Addendum #	1	Date Issued	4-19-2024
Project Name Job #	DSU Woods Hall Improvements - Phase 2		20233600
Bid Date Time	April 24, 2024		2 pm MDT

THIS ADDENDUM AMENDS AND BECOMES PART OF THE CONTRACT DOCUMENTS FOR EAPC PROJECT 20233600 DATED 1-16-2024. EACH BIDDER SHALL ACKNOWLEDGE RECEIPT OF THIS ADDENDUM BY MARKING THE ADDENDUM NUMBER AND DATE ON THE BID FORM.

P1.1

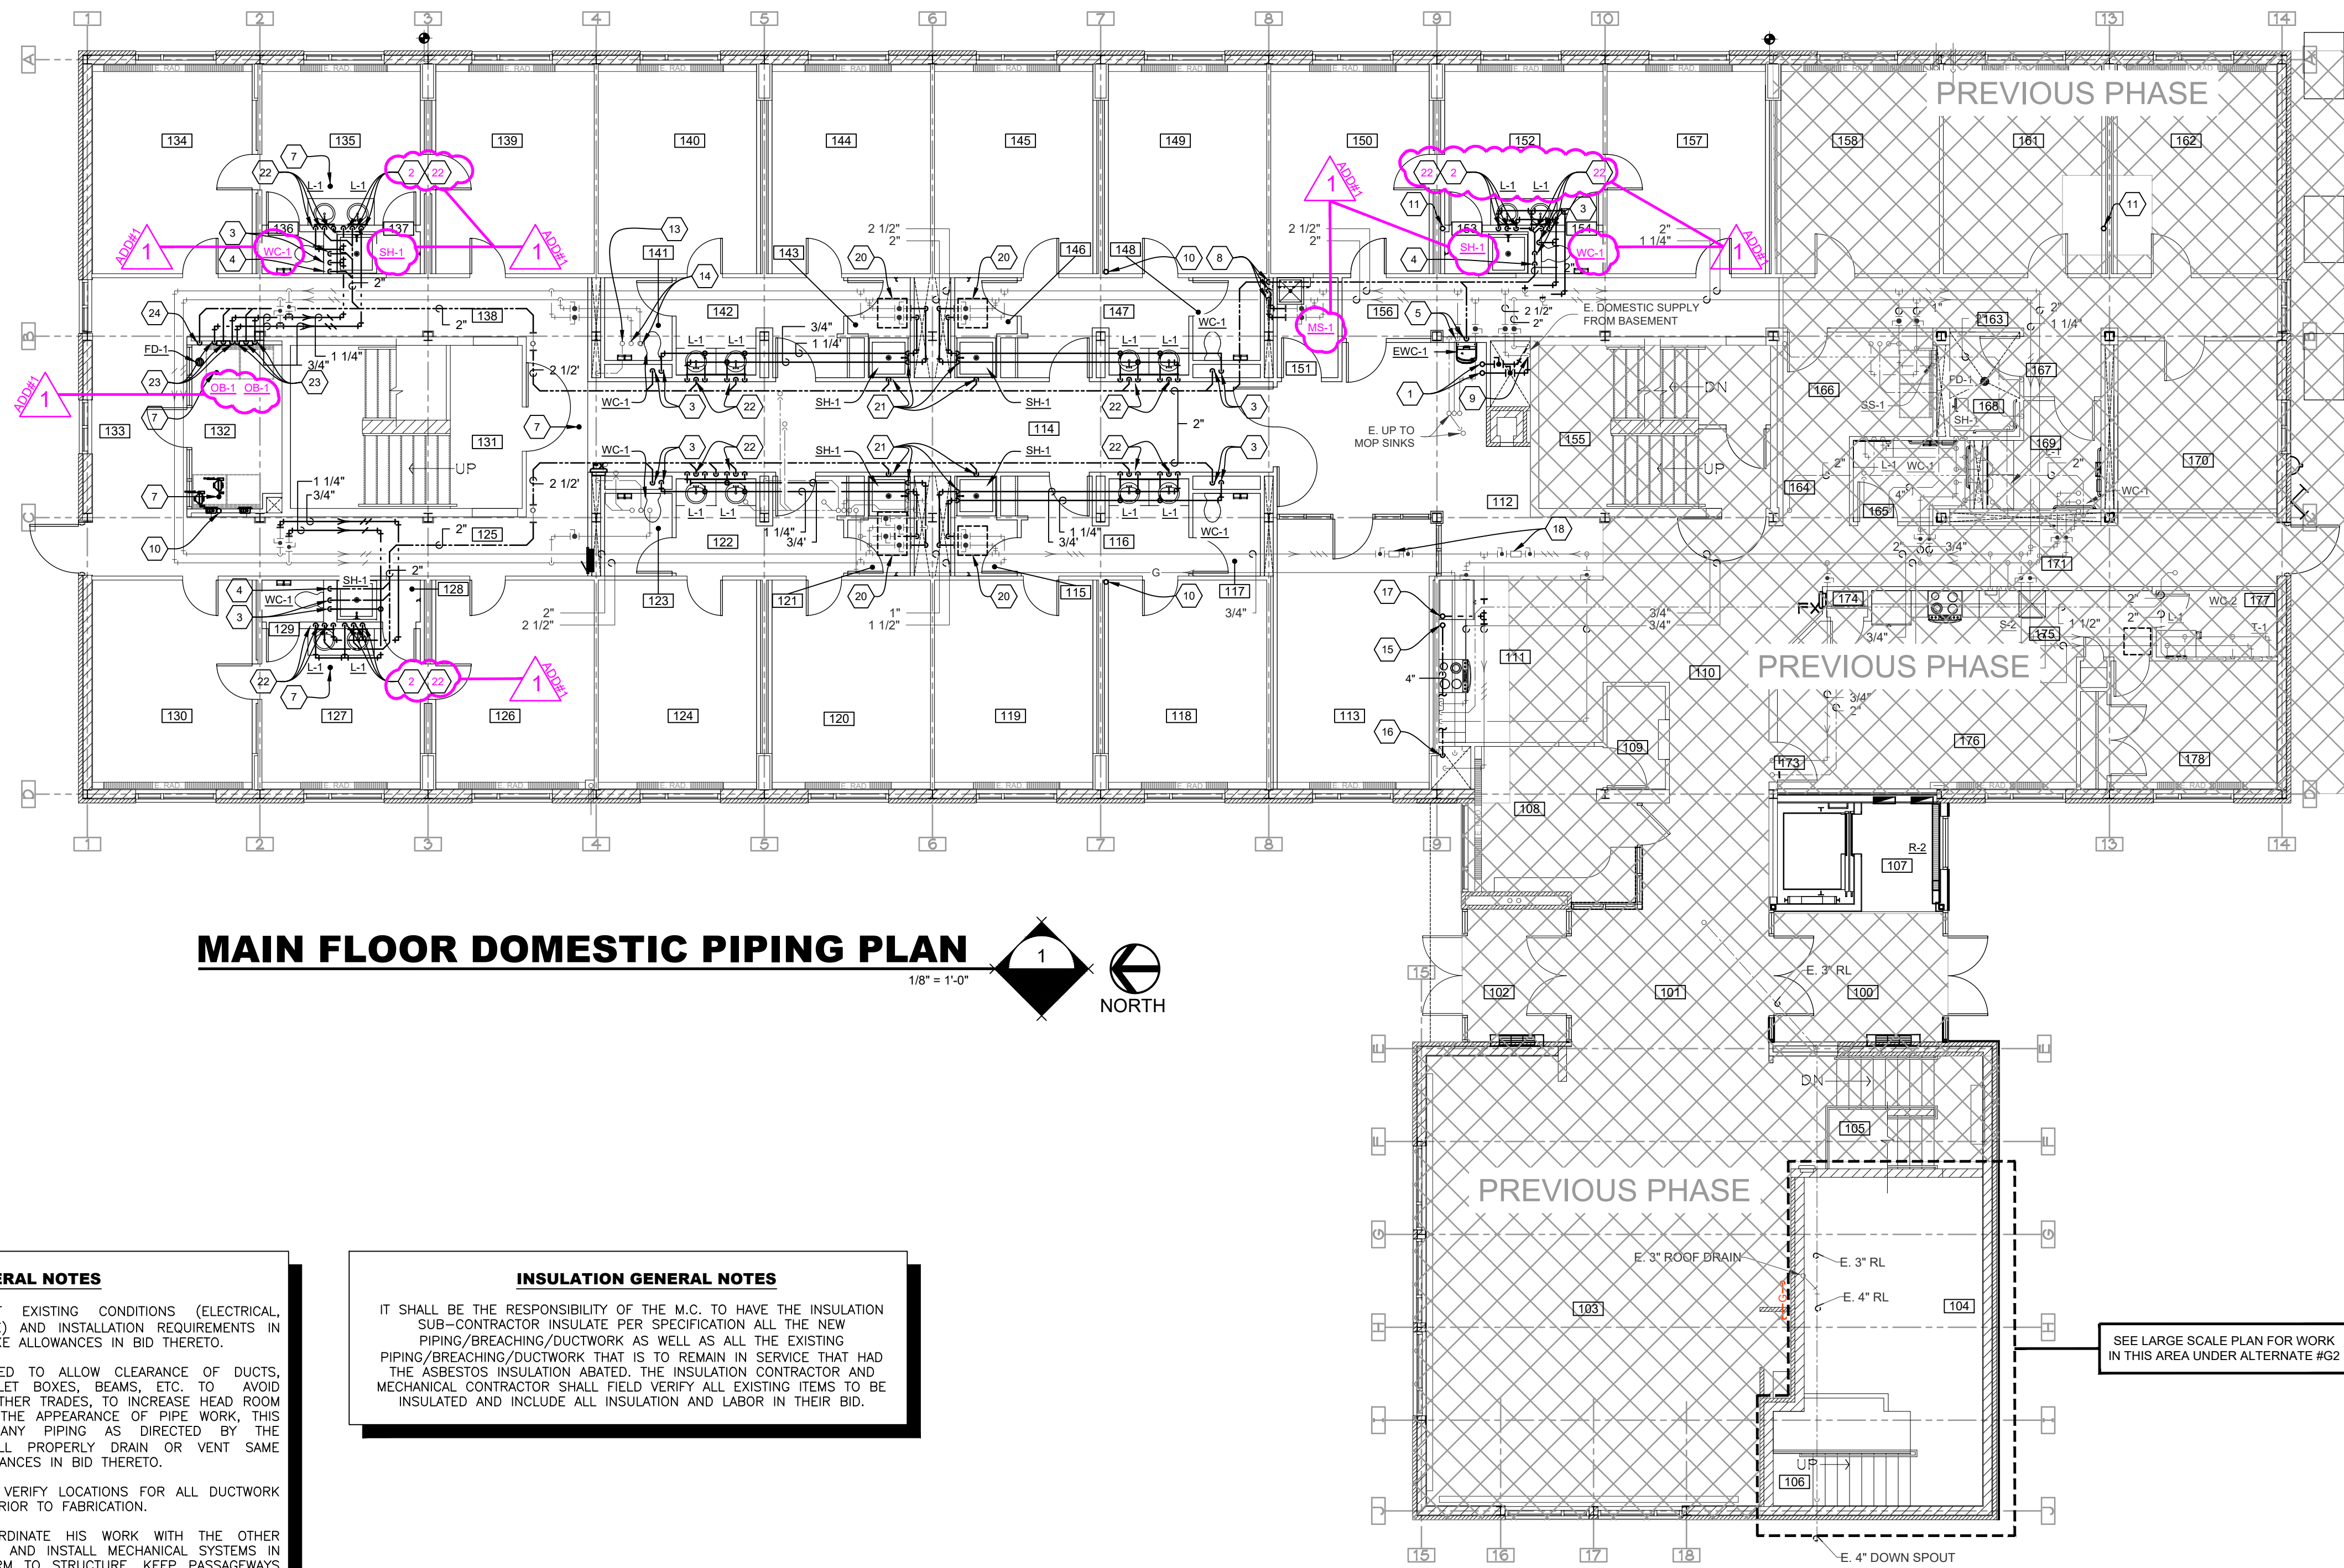
ITEM #13: SHEET P1.1 – Basement Domestic Piping Plan

- a. All water closets shall be labeled as WC-1 in lieu of some labeled as WC-2.
- b. All mop sinks shall be labeled as MS-1 in lieu of JS-1.
- c. All clothes Washer outlet boxes shall be labeled as OB-1 in lieu of SS-1.
- d. All showers shall be labeled as SH-1 in lieu of some labeled as SH-3.
- e. Added correct verbiage for keynote #20.
- f. Updated keynotes in rooms 127, 135, & 152.

P1.3

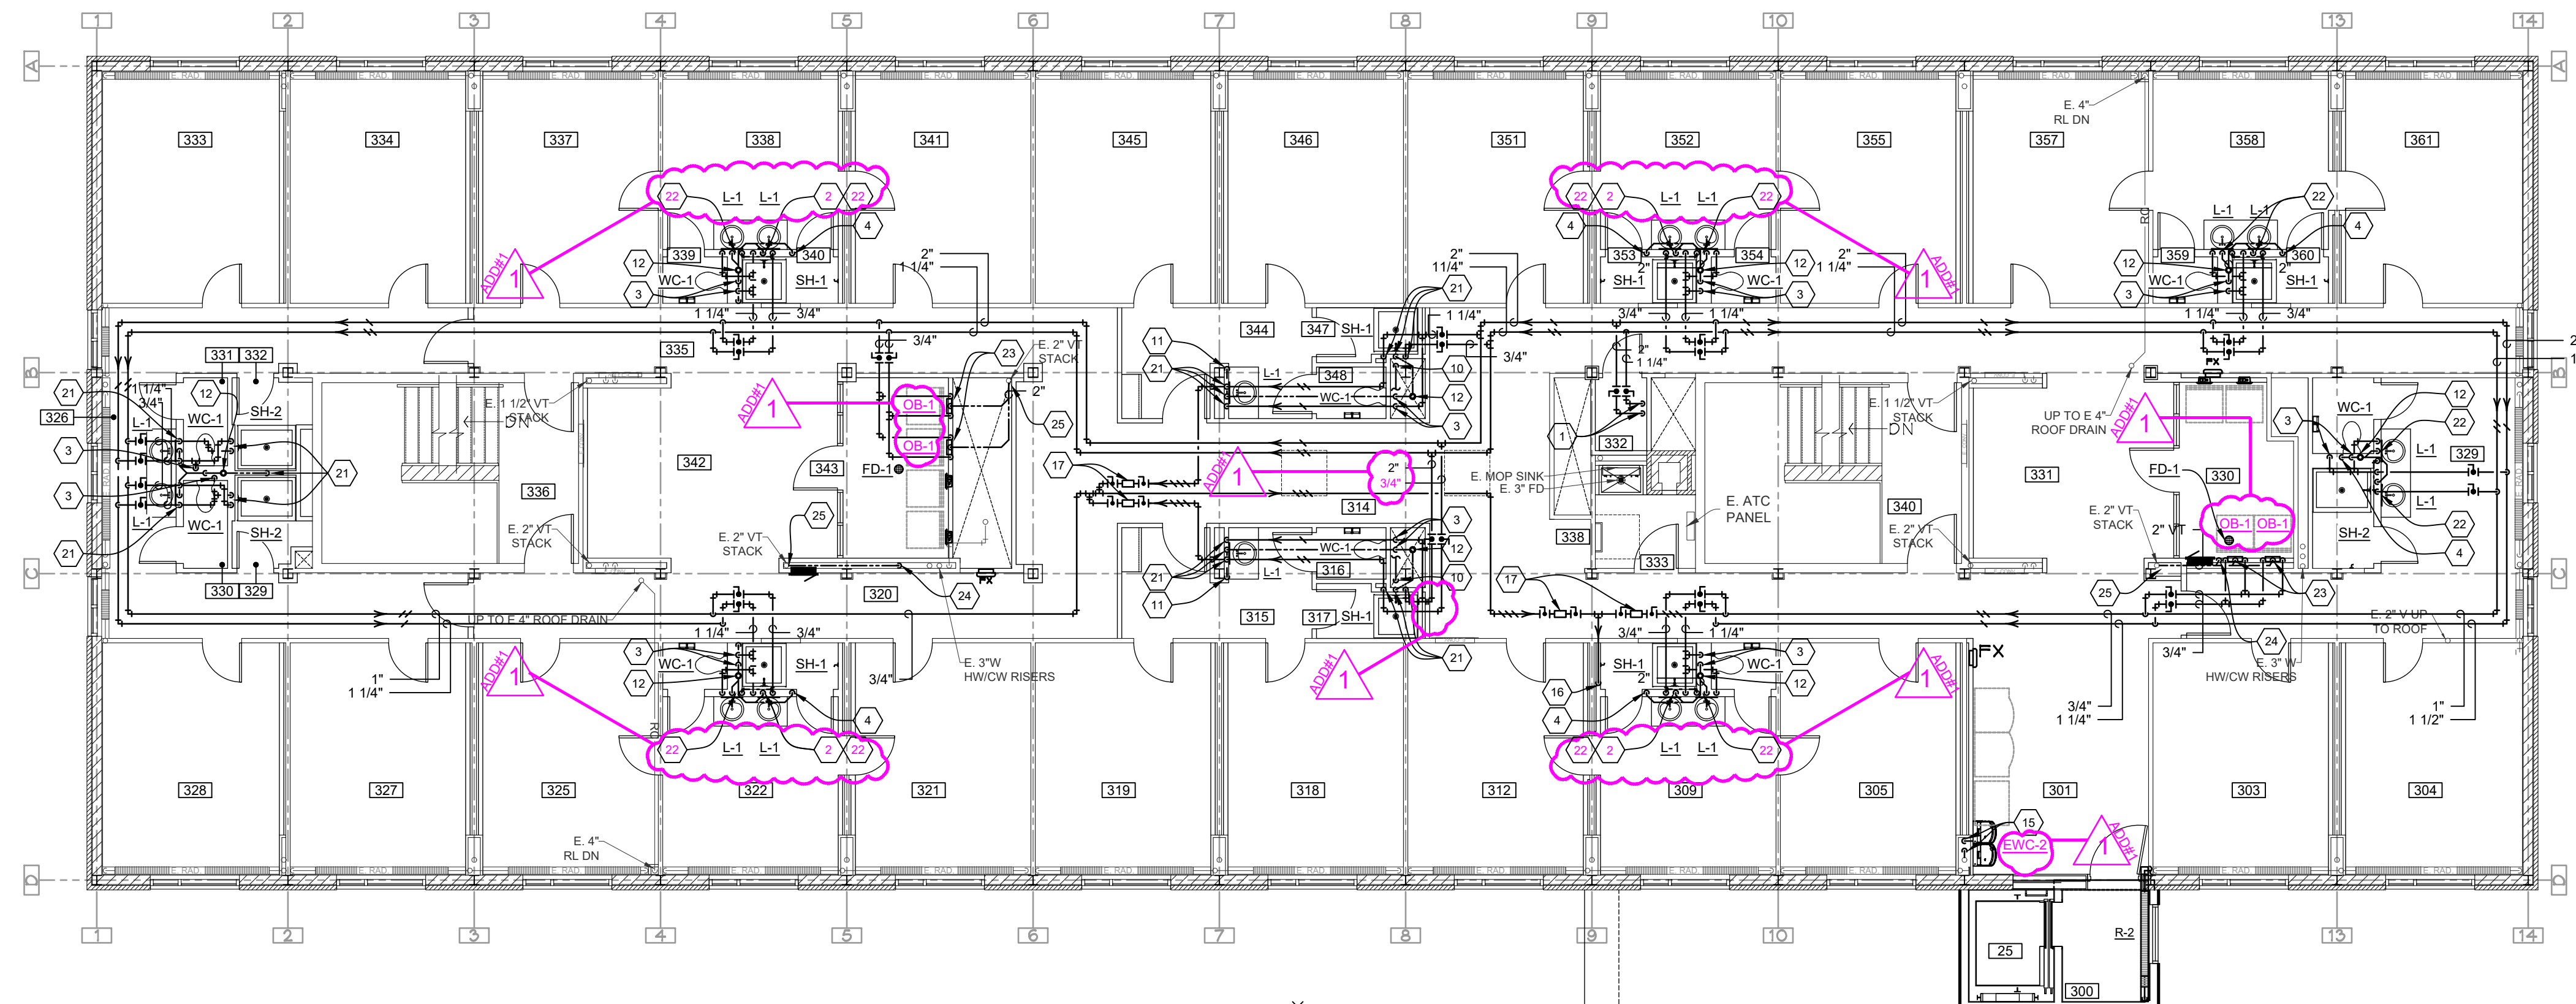
ITEM #14: SHEET P1.3 – Third Floor Domestic Piping Plan

- a. All clothes Washer outlet boxes shall be labeled as OB-1 in lieu of SS-1.
- b. Updated keynotes in rooms 309, 332, 338, & 352.
- c. Corrected sizing and routing of domestic piping serving Rooms 315, 316 & 317.
- d. The electric water cooler in Room 301 shall be EWC-2 in lieu of EWC-1.
